Client:
FASTLANE PRODUCTIONS LTD

Site:
27 Tottenham Street London W1T 4RW

Drawing Title:
First Floor Plans as Proposed

Drg. No.
12/313/13

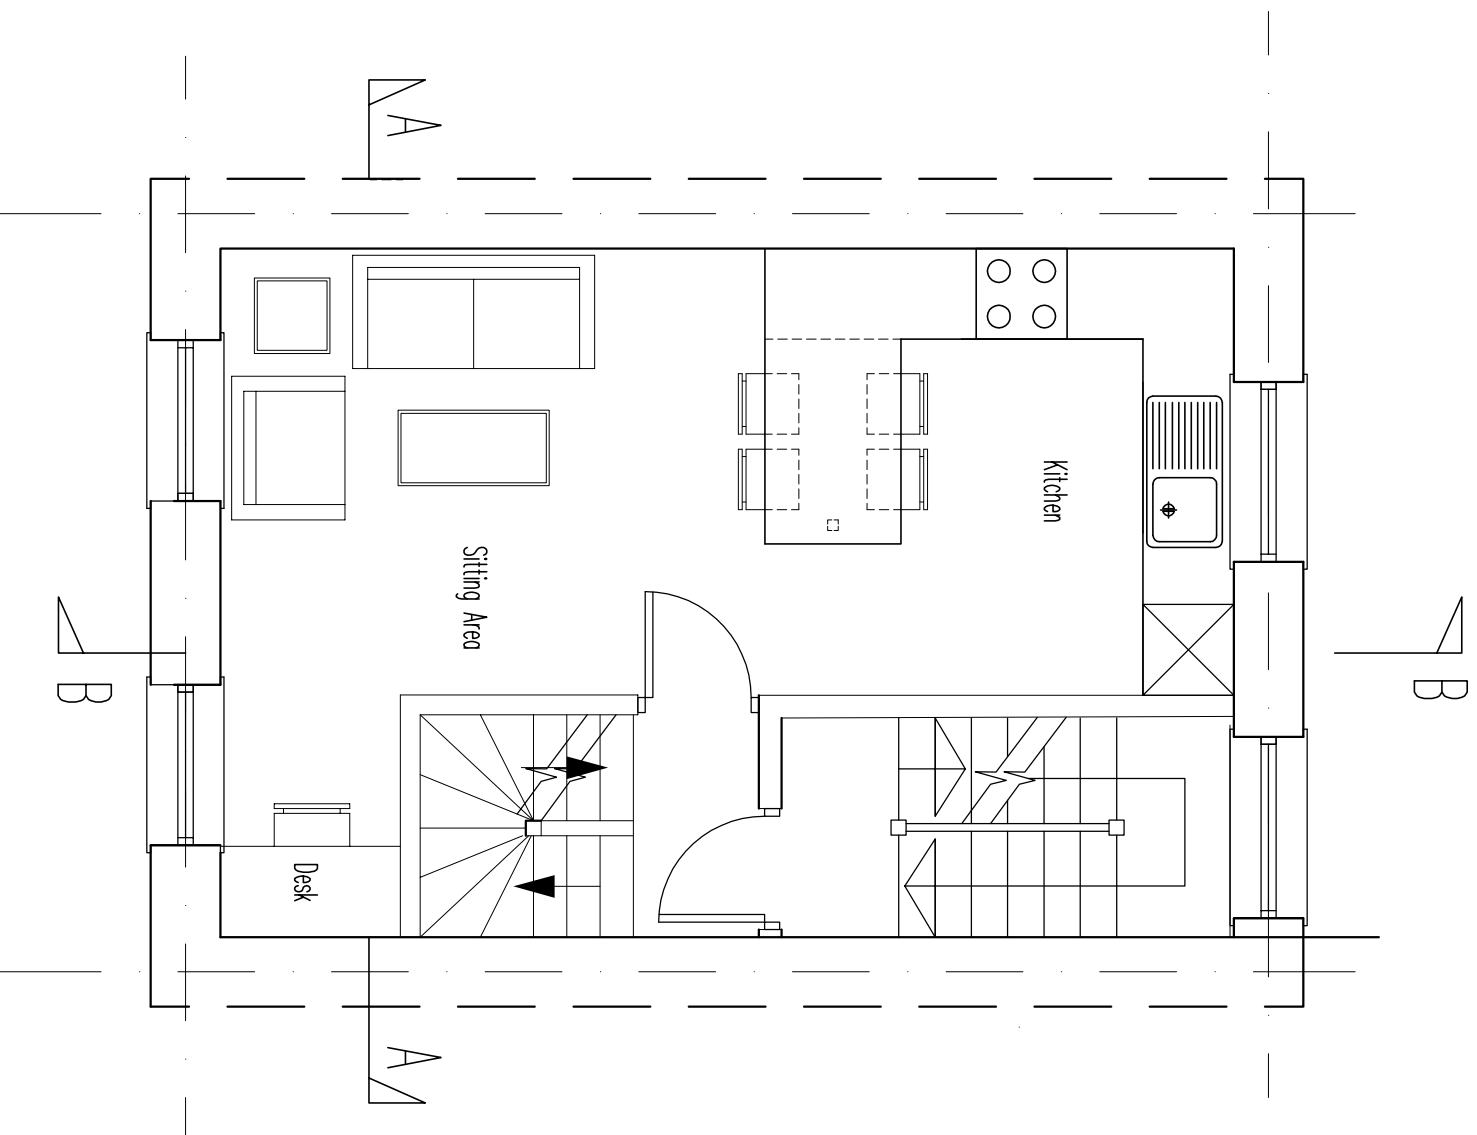
A. 1st and 2nd Floor Revised to 1x bed
mezzonette with floor above
